## SB, Hose comes lose, WT15, 2021-02

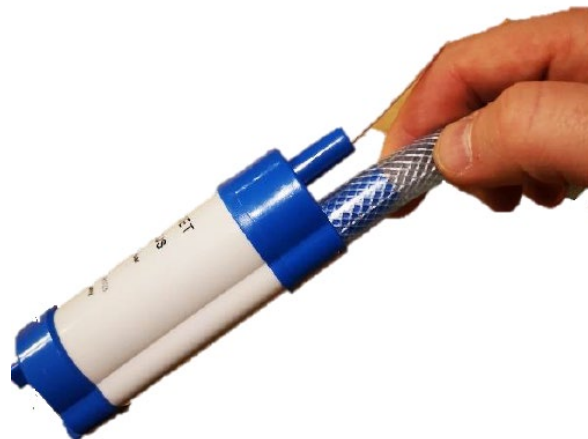
Field reports have shown that the hose that connects to the pump in the WT15 can come loose. To remedy this we have glued the hose to the pump.

1. Clean the surface where the hose should sit.  
Apply glue (Loctite 406) to the pump all around where the hose should sit.

2. Mount the hose on the pump and let it rest for five minutes.
3. Do not use any hose clamp.
